**Service
Bulletin**

**B0303010
2003-6**

Subject: Gen II and BAM Deck Belt Adjustments

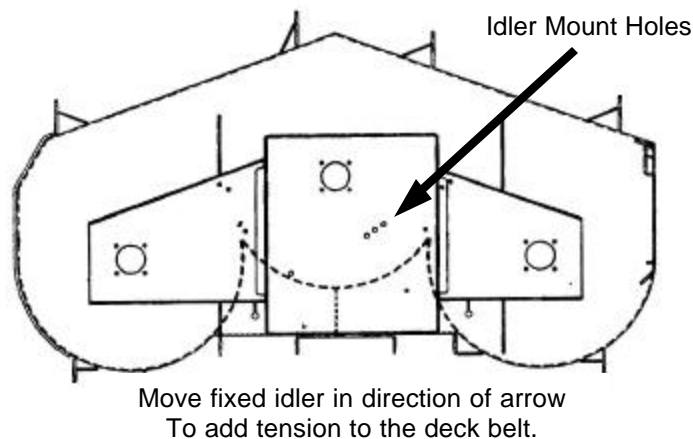
The thinner fixed idler on the mower deck, part number 539 103257, can be adjusted to add tension to the deck belt to eliminate belt bounce. This idler mounts thru the deck usually in the forward most or center of three hole locations illustrated below.

To add tension, remove the deck belt; remove the thin fixed idler, and move it left and rearward by one hole location. Reinstall the mower deck belt.
